1 11/6/2026 - ADDENDUM NO. 1

EROSION CONTROL PLAN FOR: CASCADES BUSINESS PARK INFRASTRUCTURE IMPROVEMENTS - PHASE 1

A SITE LOCATED IN THE CITY OF NORTH BONNEVILLE, WASHINGTON

SHEET ID
C02

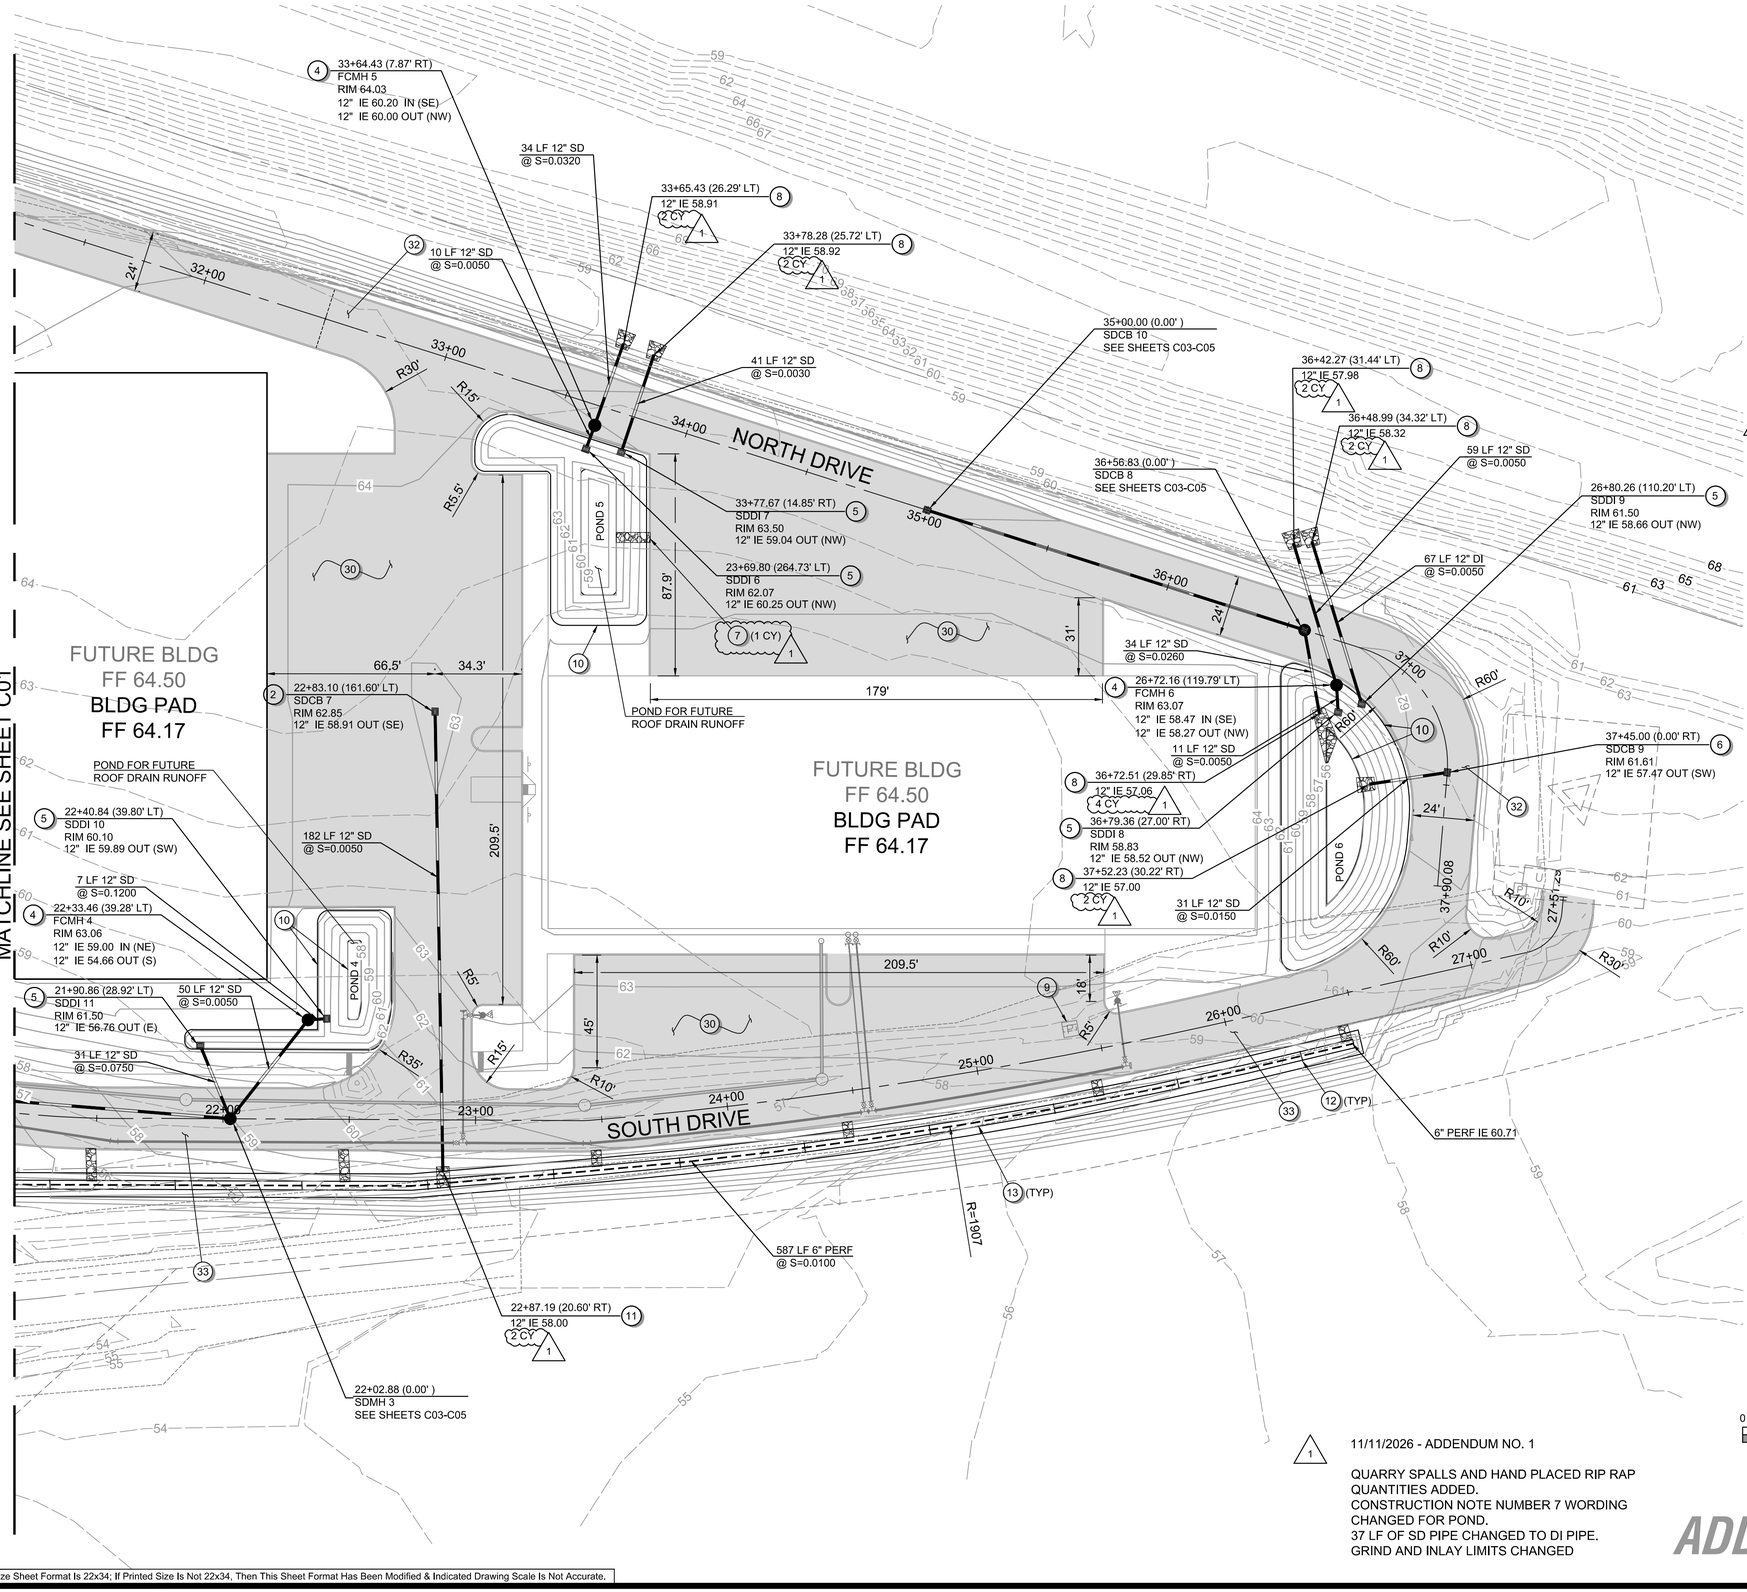
QUARRY SPALLS AND HAND PLACED RIP RAP QUANTITIES ADDED.
CONSTRUCTION NOTE NUMBER 7 WORDING CHANGED FOR POND.
37 LF OF SD PIPE CHANGED TO DI PIPE.
GRIND AND INLAY LIMITS CHANGED

5. INSTALL DITCH INLET PER DETAIL ON SHEET D01.
6. INSTALL CATCH BASIN TYPE 1 PER STANDARD PLAN B-5.20. SEE SHEET D03.
7. INSTALL 4-FOOT WIDE, 6-INCH THICK, QUARRY SPALLS PAD FROM TOP OF POND (AT LOCATION OF FUTURE CURB SCUPPER) TO BOTTOM OF POND PER DETAIL ON SHEET D01.

SHEET ID
C03

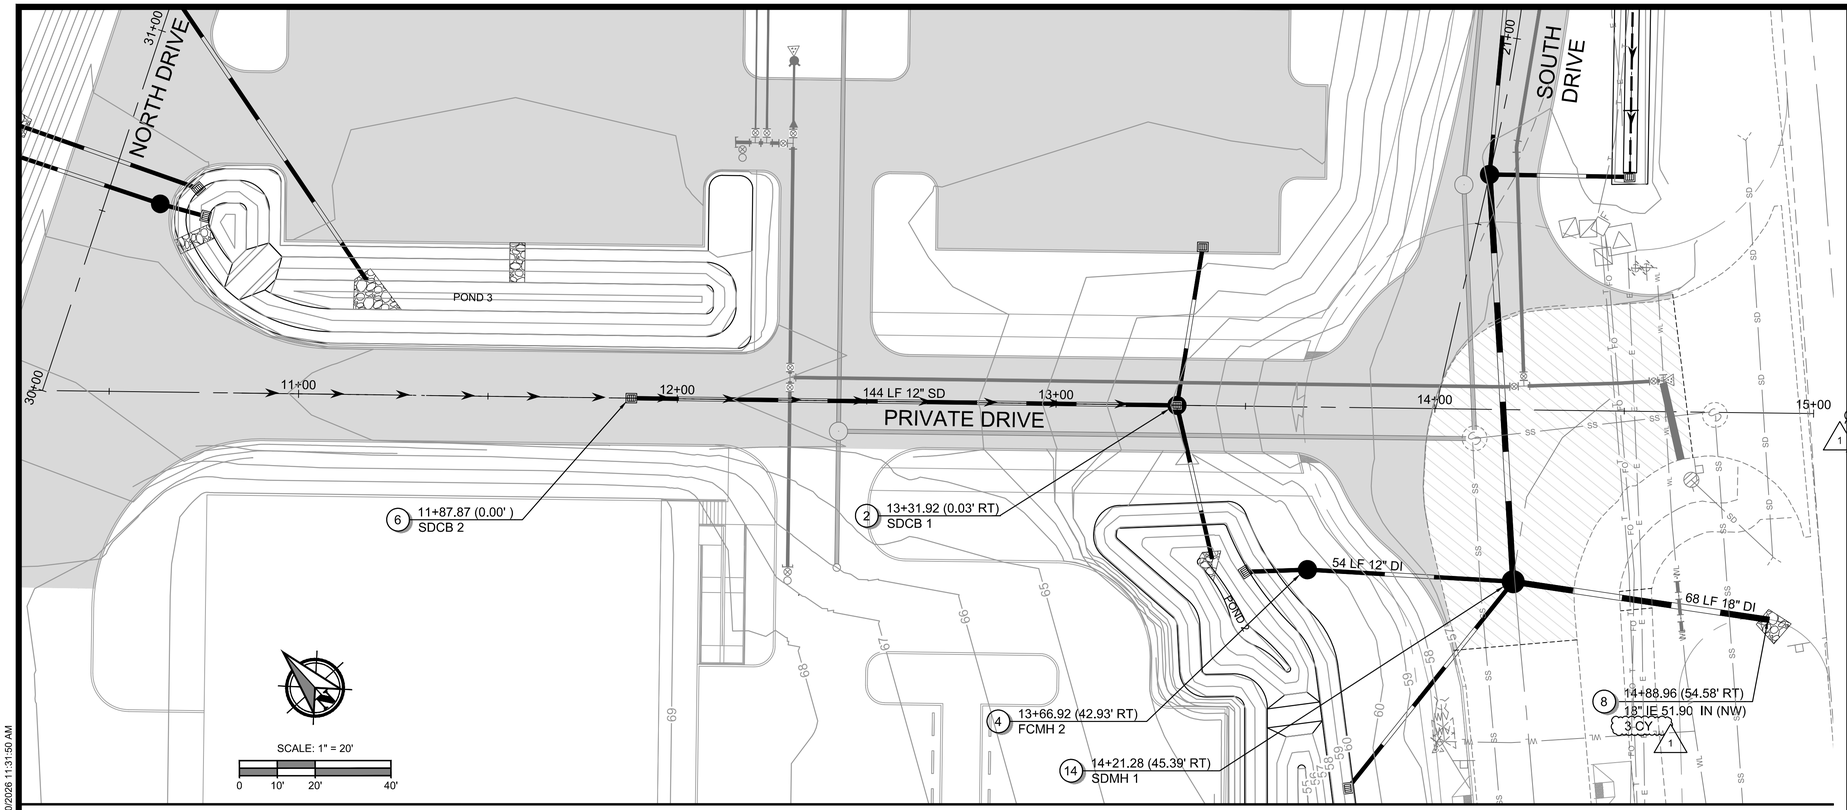
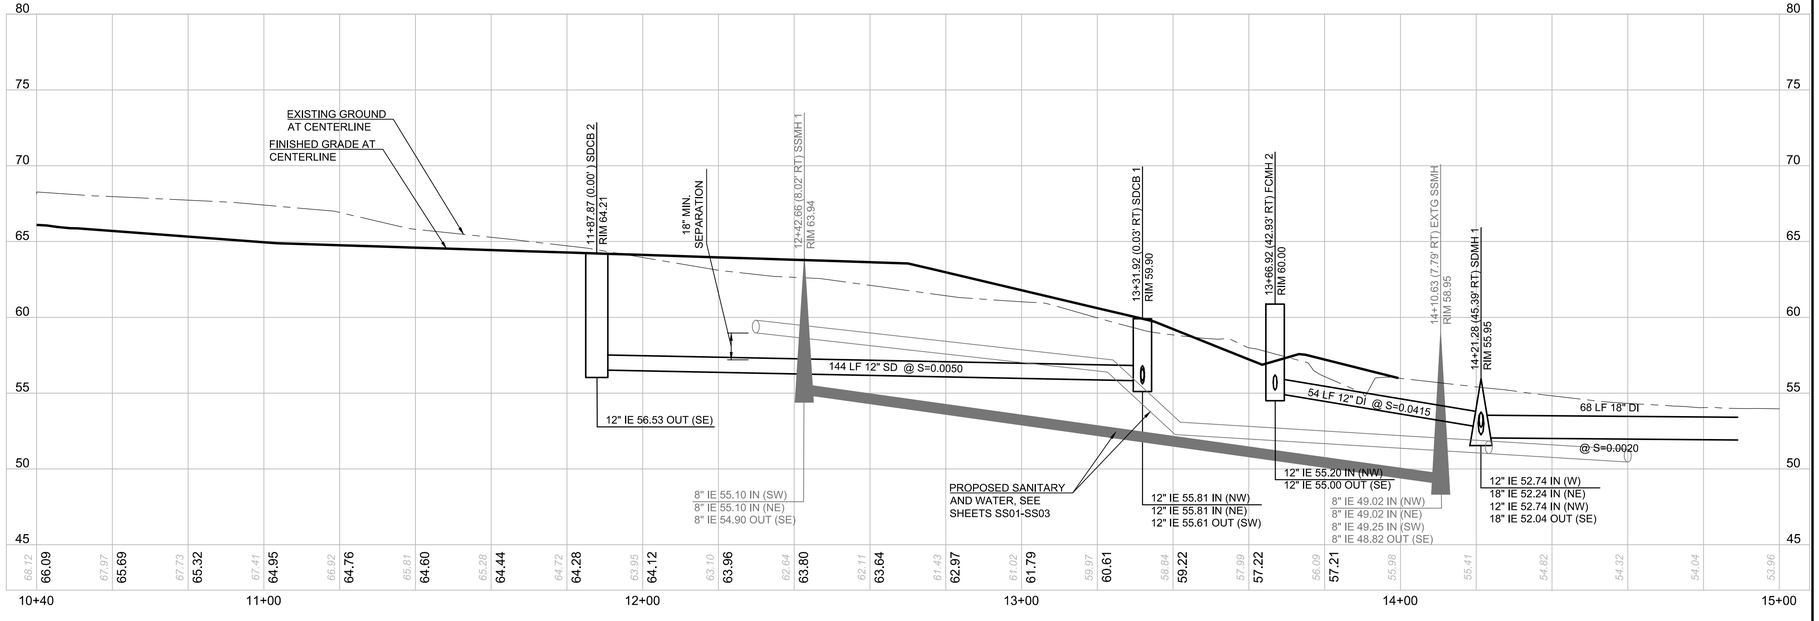
HAD PLACED RIP RAP QUANTITY ADDED. CONSTRUCTION NOTE NUMBER 7 WORDING CHANGED FOR POND.

5. INSTALL DITCH INLET PER DETAIL ON SHEET D01.
6. INSTALL CATCH BASIN TYPE 1 PER STANDARD PLAN B-5.20. SEE SHEET D03.
7. INSTALL 4-FOOT WIDE, 6-INCH THICK, QUARRY SPALLS PAD FROM TOP OF SWALE (AT LOCATION OF FUTURE CURB SCUPPER) TO BOTTOM OF SWALE PER DETAIL ON SHEET D01.

SHEET ID
C04
SHEET 15 OF 28

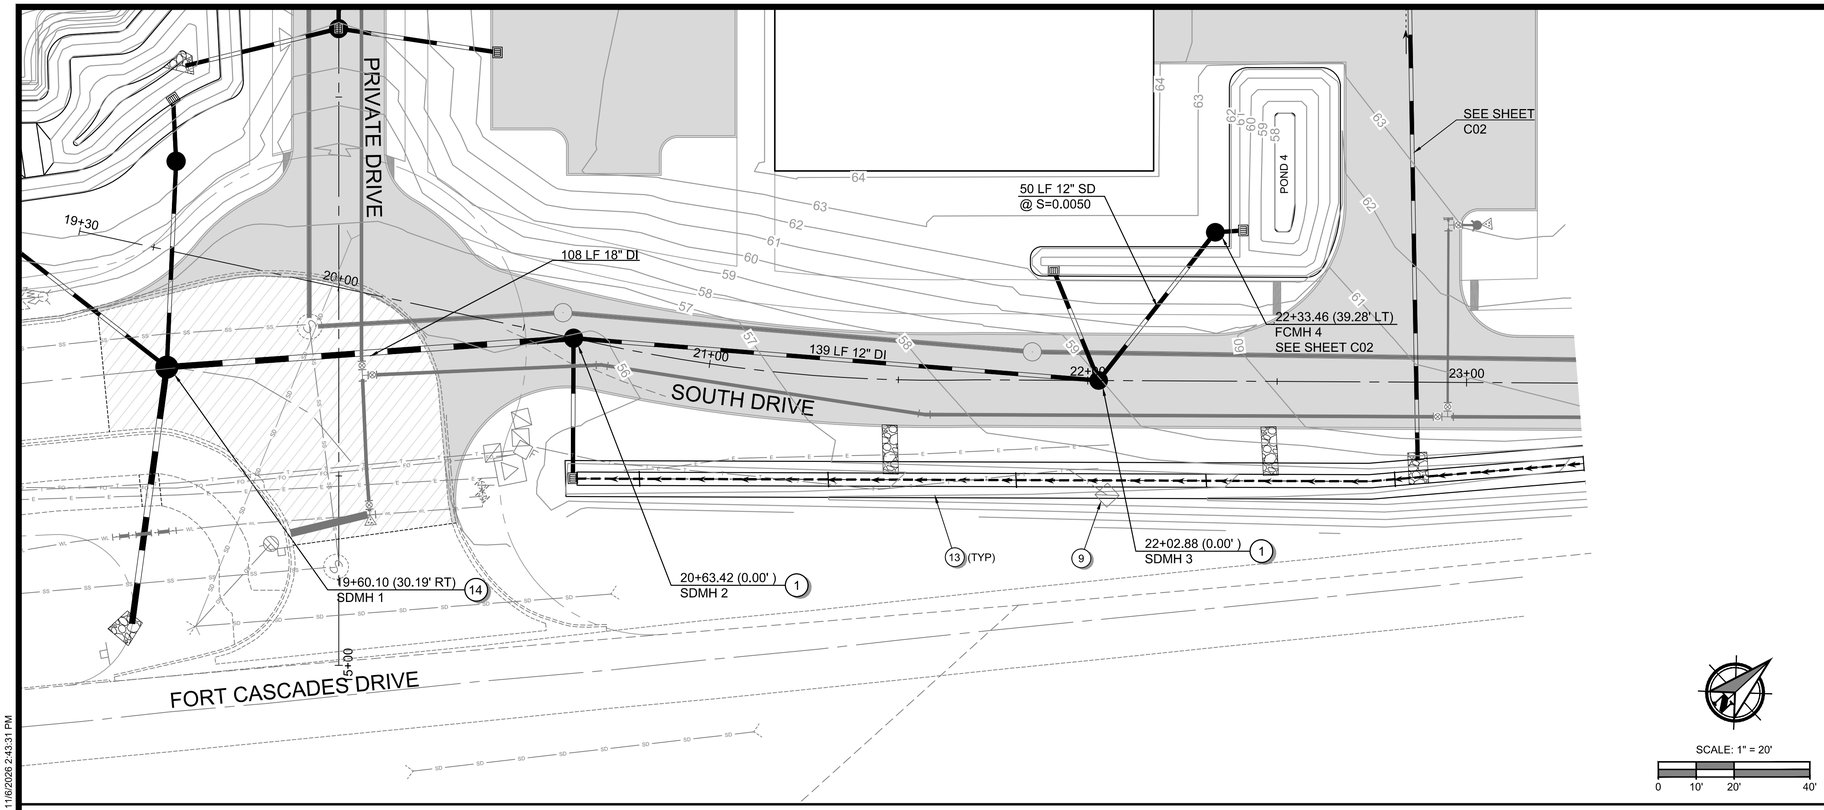
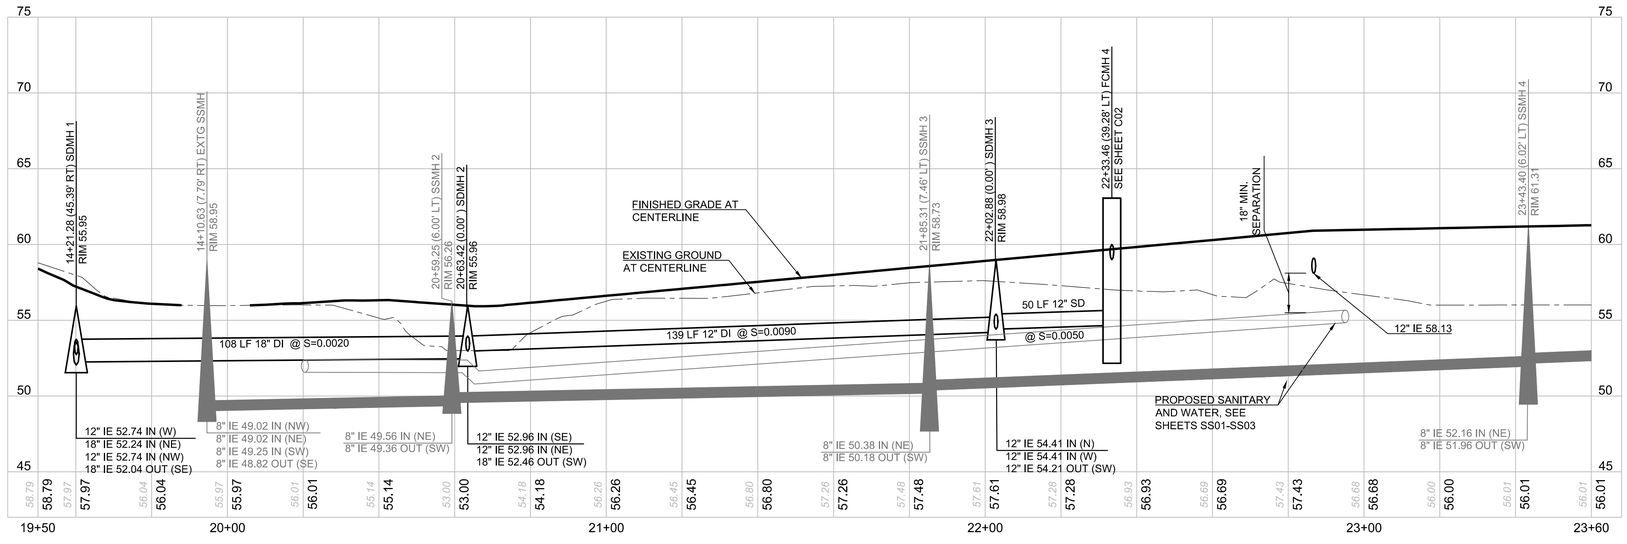
CONSTRUCTION NOTE NUMBER 7 WORDING CHANGED FOR POND.

5. INSTALL DITCH INLET PER DETAIL ON SHEET D01.
6. INSTALL CATCH BASIN TYPE 1 PER STANDARD PLAN B-5.20. SEE SHEET D03.
7. INSTALL 4-FOOT WIDE, 6-INCH THICK, QUARRY SPALLS PAD FROM TOP OF SWALE (AT LOCATION OF FUTURE CURB SCUPPER) TO BOTTOM OF SWALE PER DETAIL ON SHEET D01.

DESIGNED:	ANT
CHECKED:	JBA
NOVEMBER 2026	78260.000
SHEET ID	C05
SHEET	16 OF 28

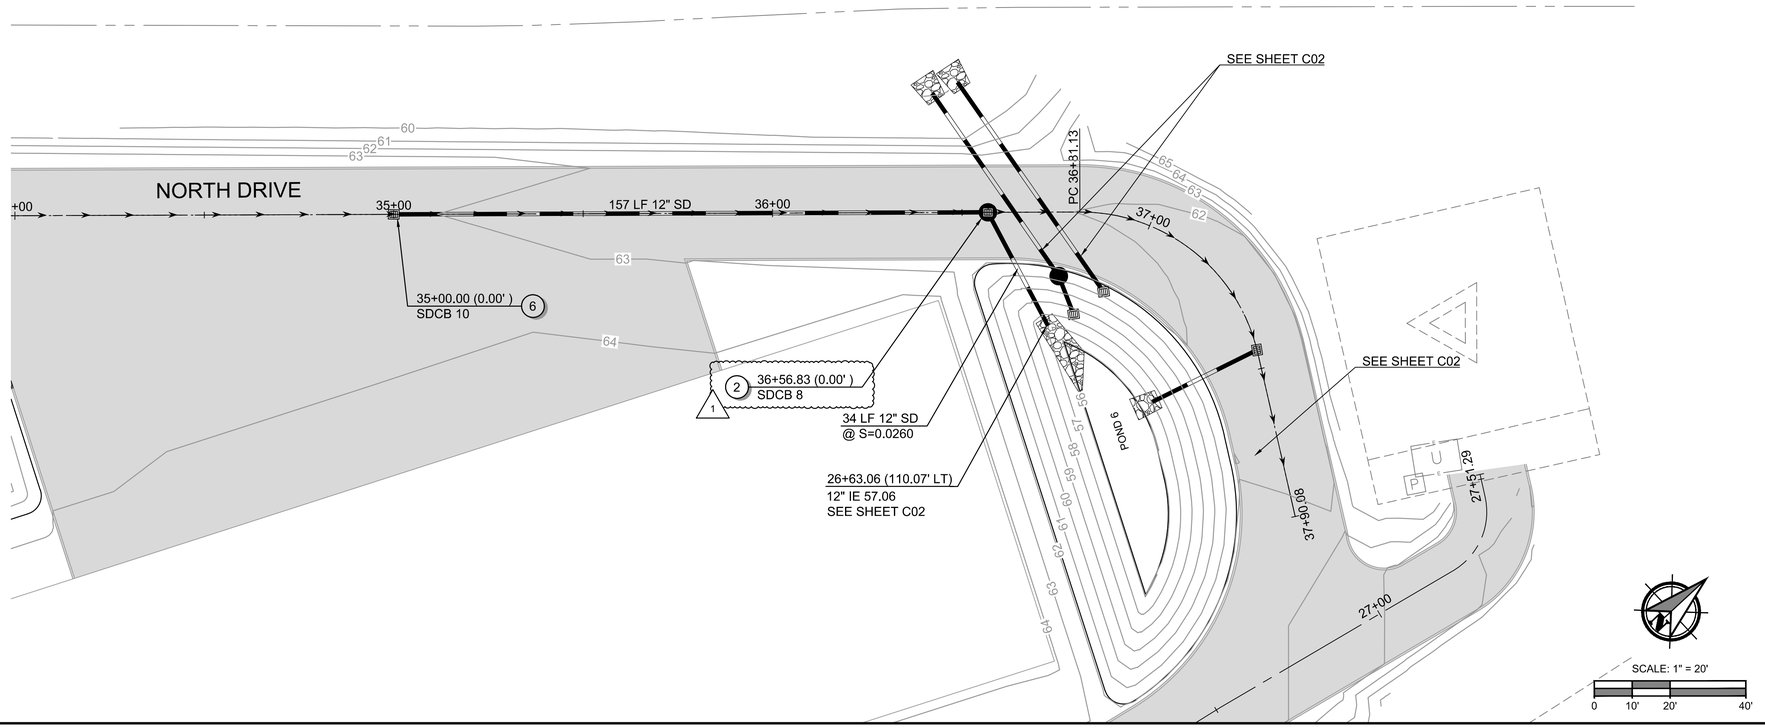
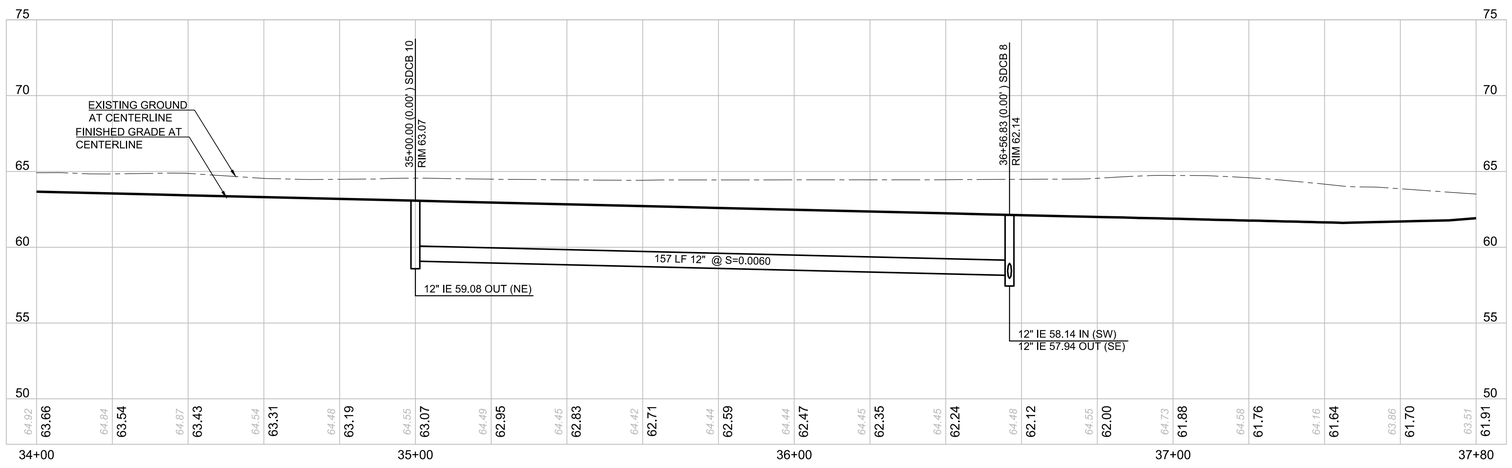
CATCH BASIN TYPE 1 CHANGED TO CATCH BASIN TYPE 2. CONSTRUCTION NOTE NUMBER 7 WORDING CHANGED FOR POND.

5. INSTALL DITCH INLET PER DETAIL ON SHEET D01.
6. INSTALL CATCH BASIN TYPE 1 PER STANDARD PLAN B-5.20. SEE SHEET D03.
7. INSTALL 4-FOOT WIDE, 6-INCH THICK, QUARRY SPALLS PAD FROM TOP OF SWALE (AT LOCATION OF FUTURE CURB SCUPPER) TO BOTTOM OF SWALE PER DETAIL ON SHEET D01. (1)
